**SMYRNA SCHOOL DISTRICT**  
**Smyrna Elementary School Renovations and Addition**  
**Bid Number SSD-15-001**

ADDENDUM NO. 4

2 April 2015

ARCHITECT'S PROJECT NO: 14107a

DATE: 04-02-15 DRAWING NUMBER:  
SCALE: 1/8" = 1'-0" A80-02

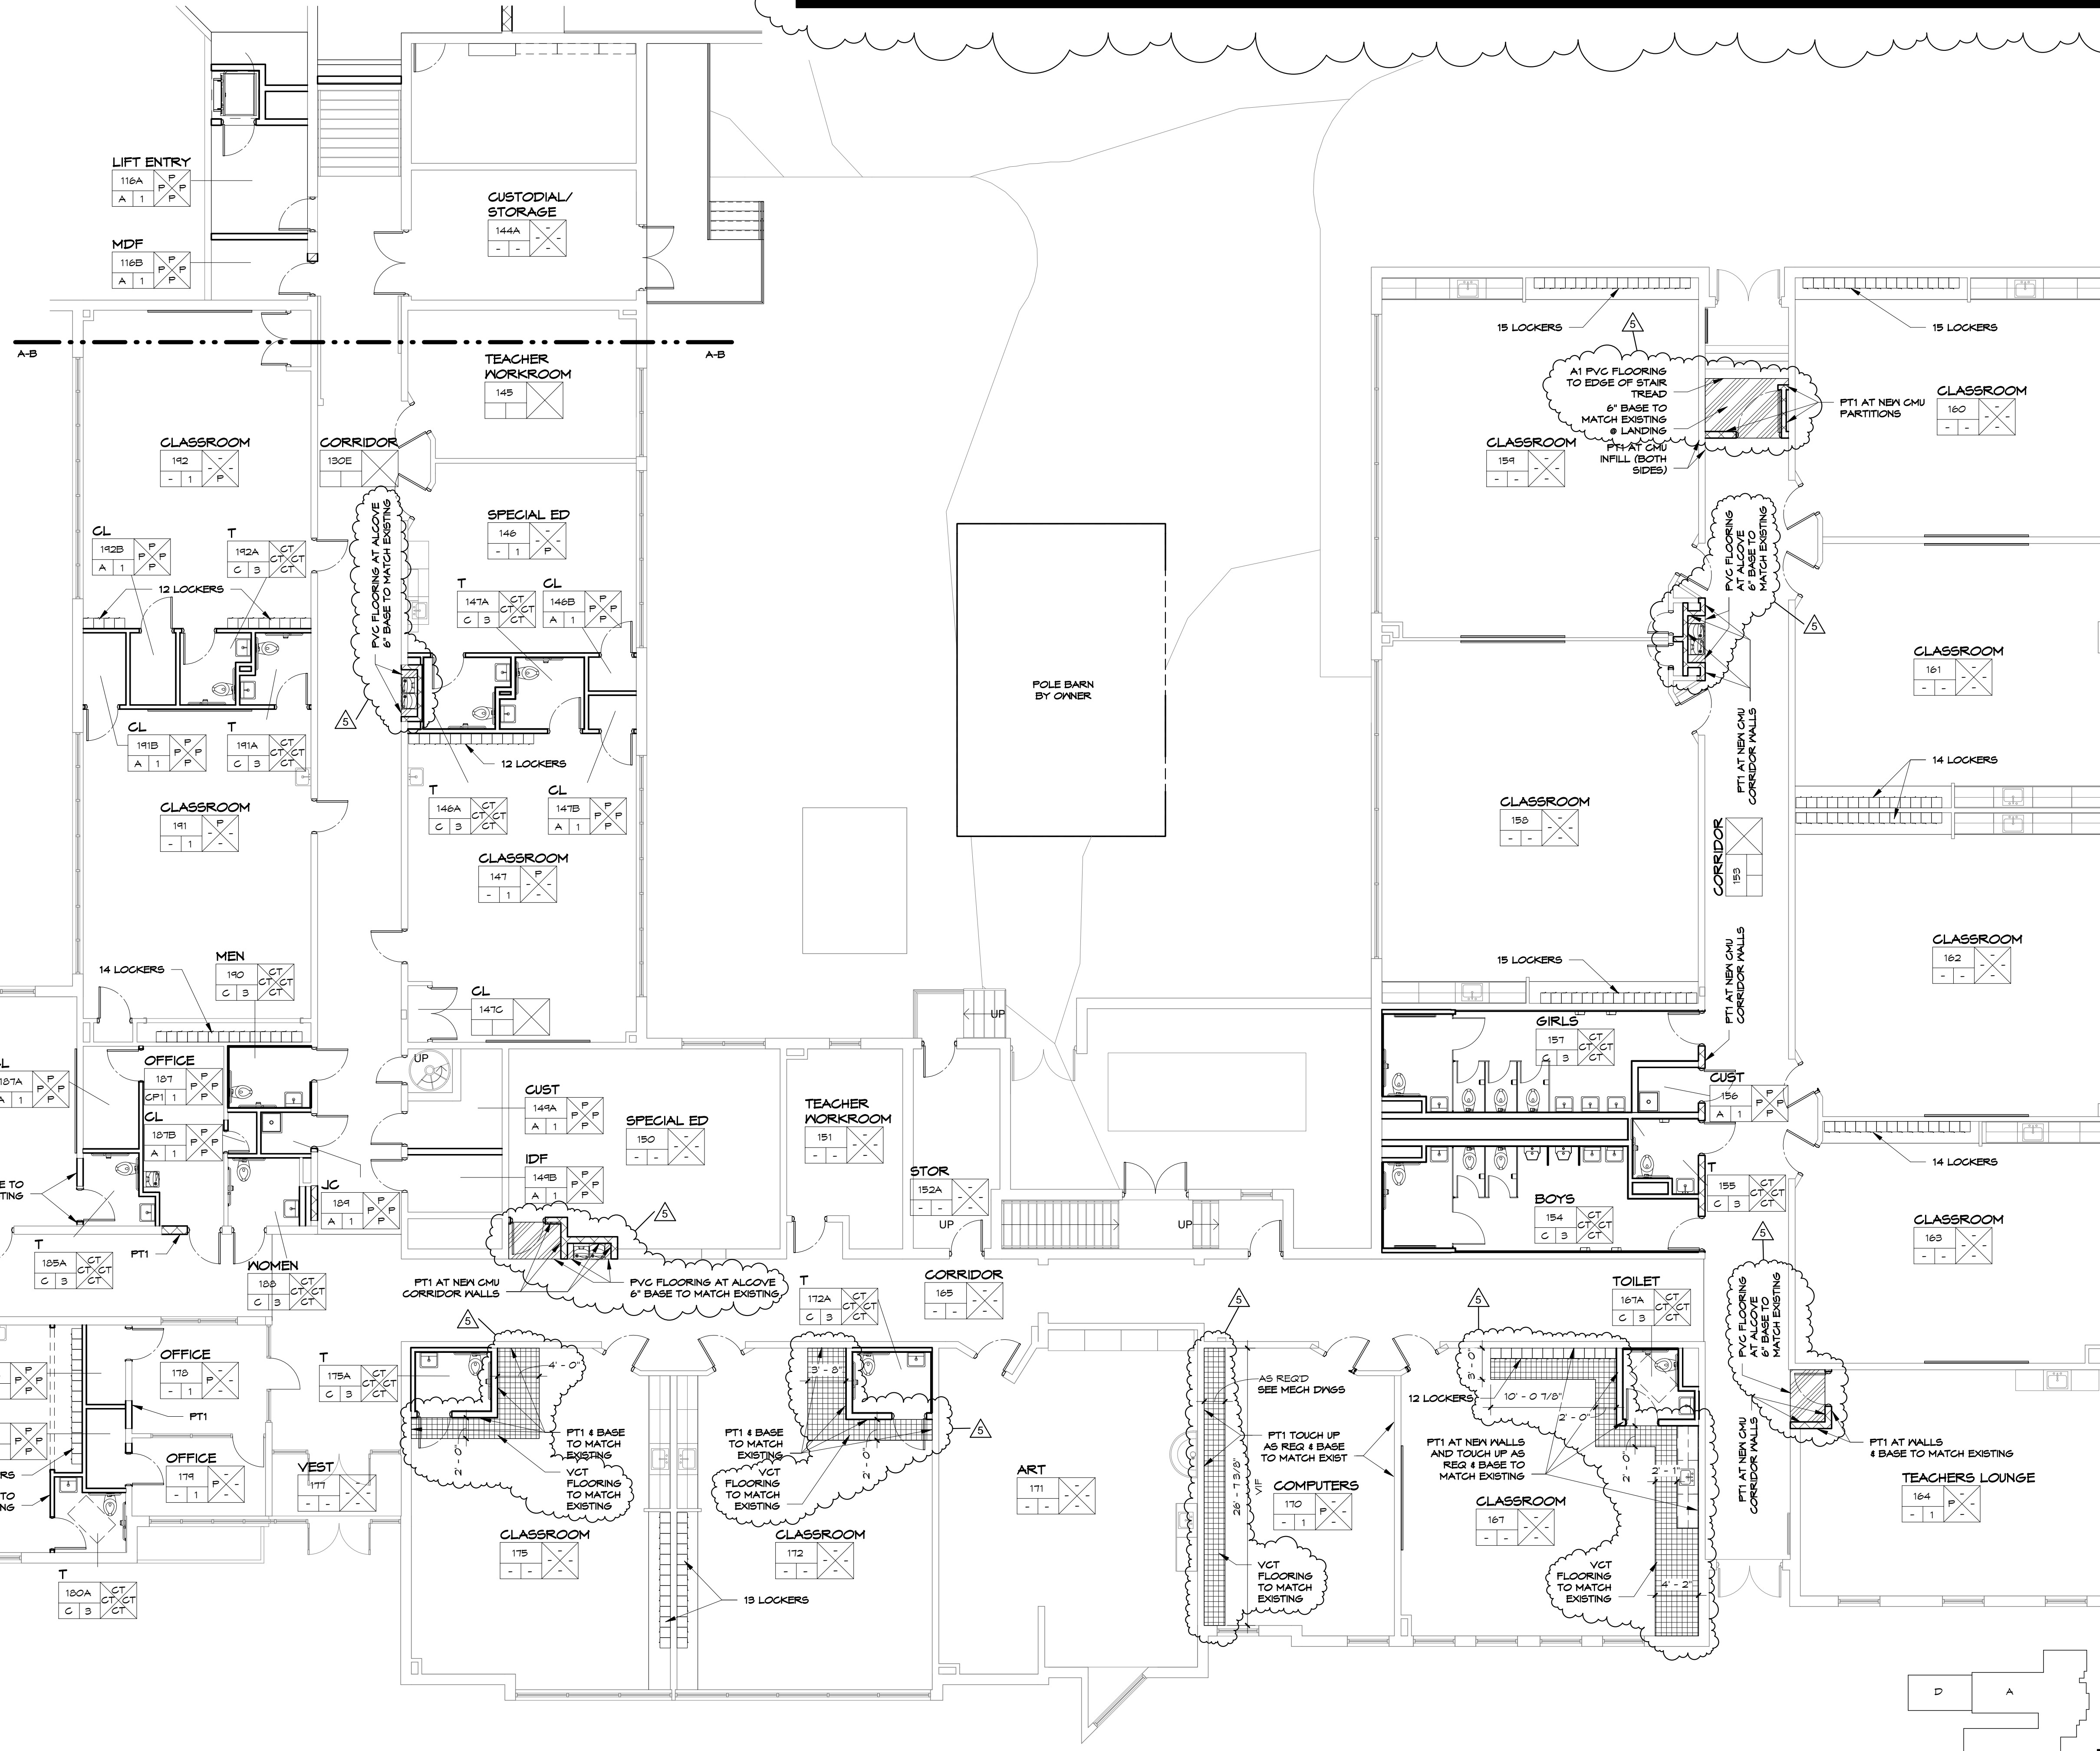
2.13 **Q:** Is there a manufacturer and style for the base to be matched in the hallways?

2.15 **Q:** Solid surface countertops are noted to match architect’s sample, are there colors selected?

2.16 **Q:** Resilient Tile Flooring spec page 2, item 2.1.A states “solid PVC floor tile according to the Finish Drawings and Schedule”, however Finish Plans A80-01 & A80-02 do not list the product to be used. Please advise.

2.17 **Q:** What is the specific product/mix level to be bid on color groups for ceramic tile? No specific colors or color groups are given in the documents

2.18 **Q:** What is the specification for carpet? There is no specification?

**A:** See Finish Specifications and Legend located on revised Sheet A80-02.

Base at Corridor 113: 4” Black

Base at remainder of Areas A, B, & C: 6” Beige

**A:** See Finish Specifications and Legend located on revised Sheet A80-02.

**A:** Existing PVC floor tile is Manufacturer: Toli ; Style Linotesta; Size 17.7”, Gauge .120”. See Finish Specifications and Legend located on revised Sheet A80-02.

**A:** See Finish Specifications and Legend located on revised Sheet A80-02.

**A:** See Finish Specifications and Legend located on revised Sheet A80-02.
